PROTECT HANOVER

July 16, 2020

Virginia Water Protection Permit No. 19-2036 must be denied. This draft-permit is defective for administrative and substantive technical reasons.

Airpark Delineated Overall WOUS Map

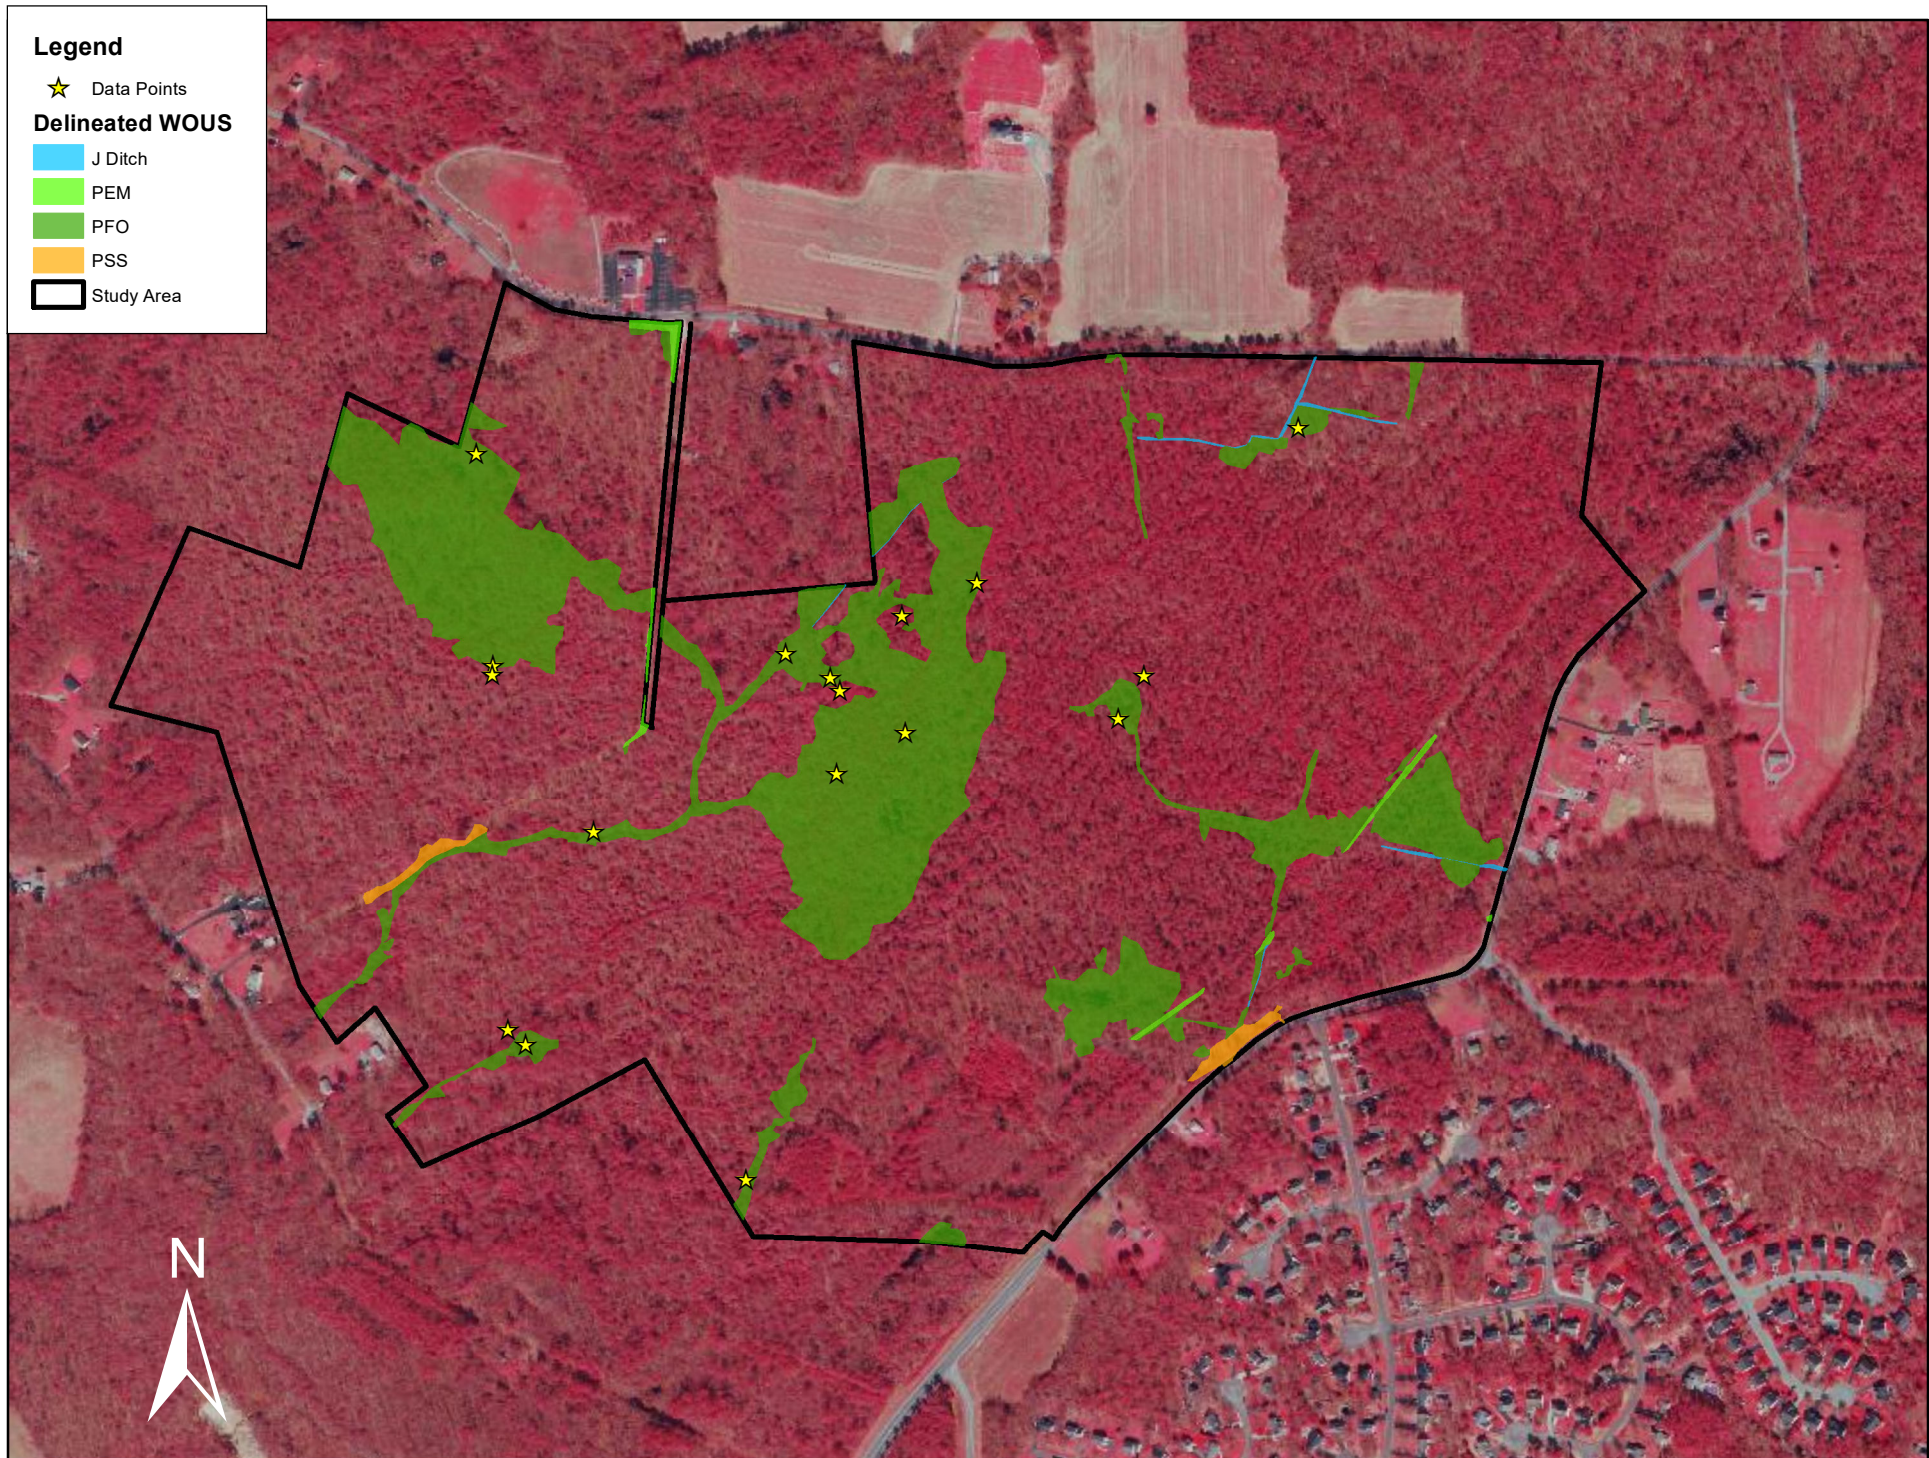
- **The Airpark property delineation was improperly conducted during a drought:**
 - At the request of Airpark Associates, RK&K conducted a wetlands delineation (count) of the project area on October 11, 2019. Their report identifies 33.8 acres of wetlands.ⁱ

- **Wetlands boundaries were reduced without justification:**
 - USACE issued a determination for the project area on December 13, 2019. This determination reduced wetlands from the 33.8 acres found by RK&K, by approximately 12.5 acres.
 - A reduction of about 4.5 of 12.5 these acres comes from the deletion of some wetland areas, and the reduction of others. Some wetlands were reduced so much that one wetlands data point, (DP2) from the RK&K report, had to be deleted because it was not within the borders of the wetlands after December 13, 2019.^{iv}
 - The location of this data point (DP2) is to become a paved road, but does not count as a wetland area that will be filled.

- **Mosaic wetlands were found despite a failure to follow the appropriate USACE process:**
 - Determining an area to be a mosaic wetland requires a data collection process involving the establishment of one or more transects.^v
 - USACE did not establish any transects to properly qualify or measure the mosaics.^{vi}
 - A reduction of about 8 of 12.5 acres results from the improper use of the mosaics.

The differences between the RK&K delineation and what was accepted by DEQ/USACE can be most easily seen in a comparison of the before and after maps. The before, titled “Airpark Delineated Overall WOUS Map,” shows what RK&K found in their work. The after, titled “Airpark Project Area, Confirmed WOUS Map,” shows the reductions clearly.

We believe that, instead of 6.12 acres, this development proposes to fill at least 18.5 acres. DEQ accepted a delineation that fails to meet the minimum statutory requirements. As a result, this draft-permit must be denied, and the applicant must do it correctly
